SERVICE BULLETIN

M-1093

Safety Recall Code 0101

VAPOR VALVE/BANK ANGLE SWITCH MOUNTING

Figure 2. Re-Mount Vapor Valve

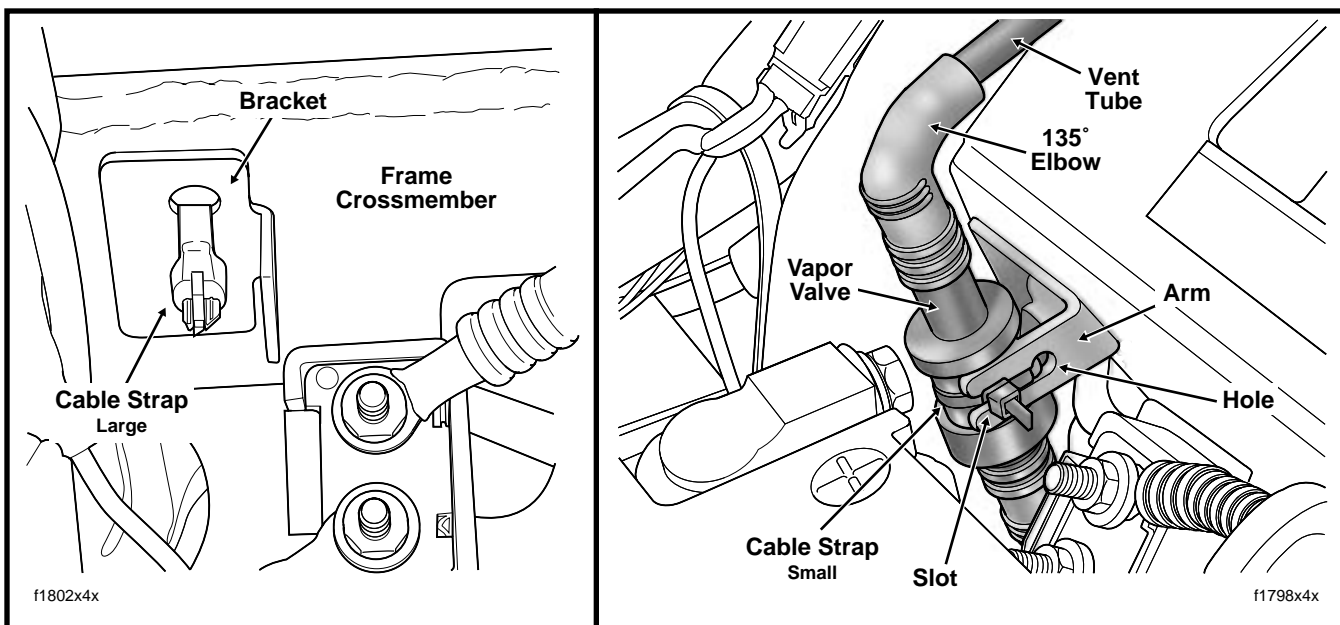
7. Feed end of cable strap through lower hole in frame crossmember and then through lower hole in bracket. Mate ends of cable strap, and using a needle nose pliers, pull strap tight. Cut any excess cable strap material. See left frame of Figure 2.

9. From right side of bracket, insert end of **small** cable strap through hole in arm and then around body of vapor valve. Mate ends of cable strap and pull tight engaging strap in slot of arm. Cut any excess cable strap material. See right frame of Figure 2.

Figure 3. Current Production Reinforcement Plate (Ultra Model Shown)

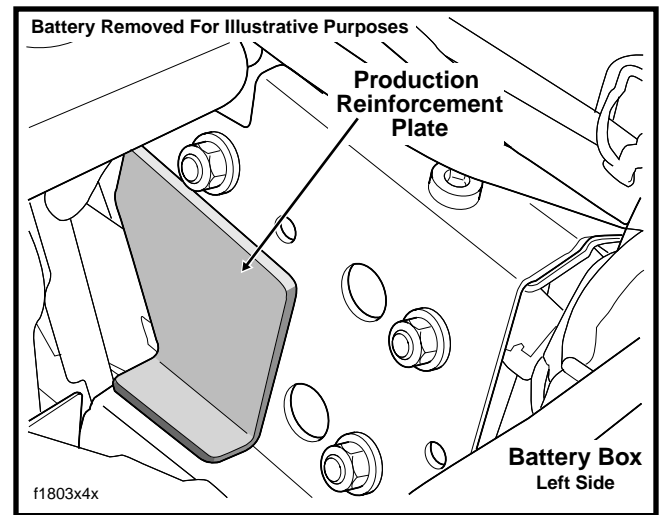
Before proceeding, look at the inside left wall of the battery box to see if a reinforcement plate has been installed in production. See Figure 3. All 2000 model vehicles built after October 14, 1999, have the plate to help eliminate the flexing/vibrating potential. Skip this procedure if the plate is present. If the plate is absent, then reinforce the existing mount using the items in the recall kit.

Figure 4. Re-Mount Bank Angle Switch

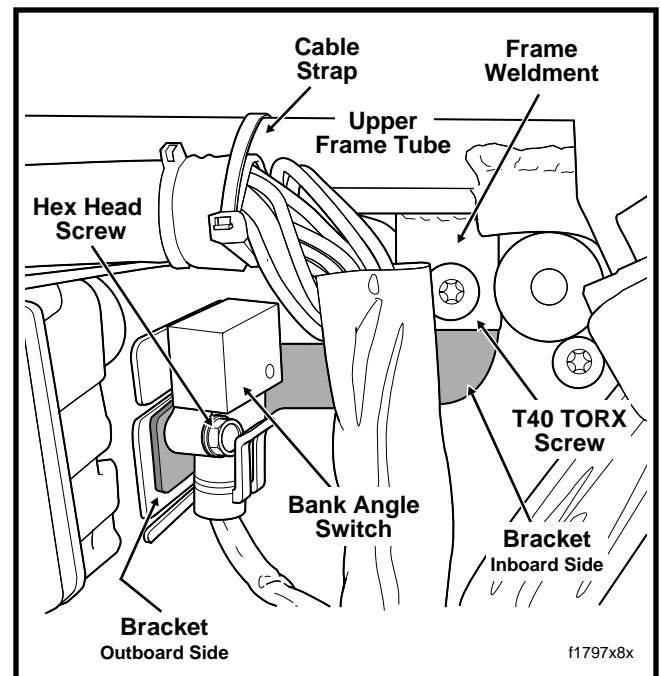
1. Obtain large bracket (P/N 77079-00), cable strap (P/N 10006), T40 TORX screw (P/N 3676), and hex head screw (P/N 2366) from kit. See Figure 1.
2. Remove hex head screw to release bank angle switch from bracket at left side of battery box. Discard screw.
3. Cut cable strap at hole in frame weldment to release wire harness conduit. Pull cable strap from hole.
4. Position bracket so that weldnut is aligned with hole from which cable strap was removed. Properly positioned, bracket must be inboard of weldment with weldnut facing fender. Start T40 TORX screw through hole in frame weldment and into weldnut on bracket. See Figure 4.

5. With connector side down, fit locating nub on bank angle switch into inboard hole on opposite side of bracket. Holding switch in position, rotate bracket so that outboard hole is aligned with hole in old bracket at side of battery box.
6. With hole in switch aligned with holes in **both** brackets, install longer hex head screw from kit. Tighten screw to 15-20 **in-lbs** (1.7-2.3 Nm).
7. Tighten T40 TORX screw to 15-20 ft-lbs (20-27 Nm).

If the wire harness is in contact with the sharp edges of the switch, the conduit and eventually the wires will be chafed or cut. To avoid electrical problems, cable strap the harness to the upper frame tube making sure there is enough clearance between harness and switch.

Figure 5. Bottom Vent Tube Routing (Charcoal Canister to Vapor Valve - California Models Only)

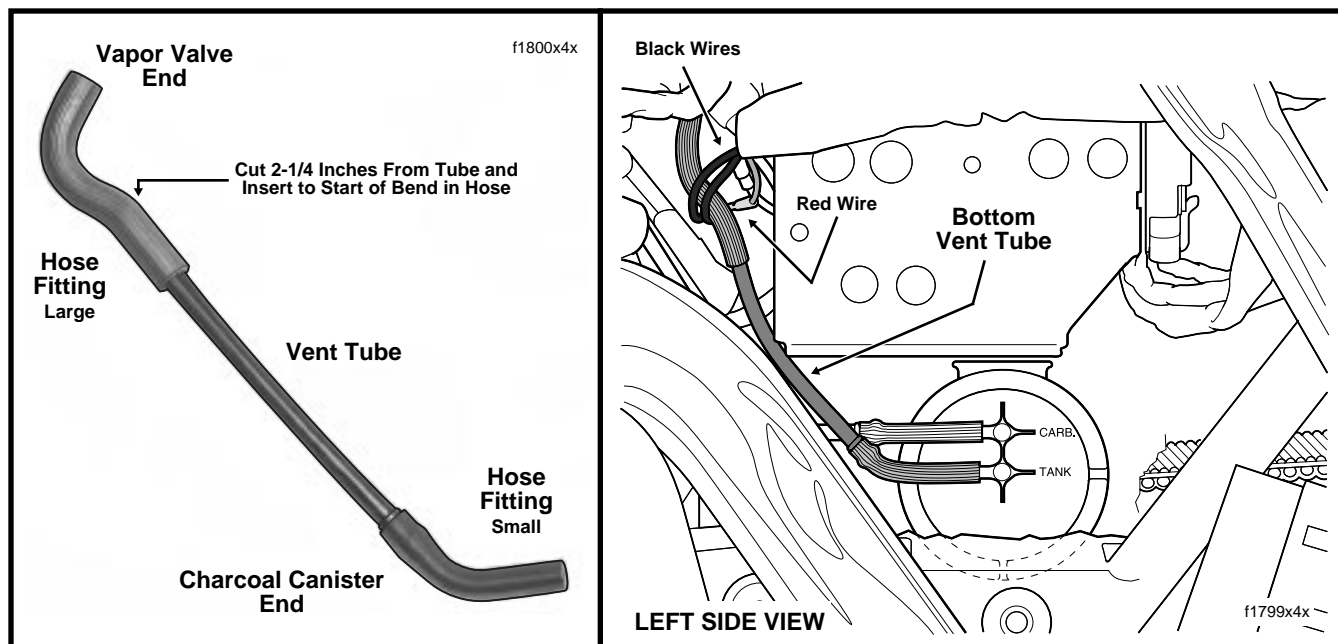
12. Remove vapor valve and bottom vent tube from vehicle.
13. Pull hose fitting on vent tube from fitting on vapor valve. Set vapor valve aside.
14. Pull hose fitting from vapor valve end of vent tube. Cut 2-1/4 inches from end of tube. Insert tube back into same end of hose fitting until end of tube just reaches start of bend in hose. See left frame of Figure 5.

19. Reach in through opening above fuse block bracket (weldment between downtubes) and attach smaller hose fitting on vent tube to bottom fitting on charcoal canister. See left frame of Figure 5.

20. Route opposite end of vent tube forward and then upward in front of battery box (stepped area) to bottom fitting on vapor valve.
To avoid interference that may influence the position of the valve, route tube in front of the red wire to the circuit breaker (silver post), and rear of the two black wires to the left side ground post. See right frame of Figure 5. If more separation is needed, use a finger to push the black wires forward and the red wire rearward.
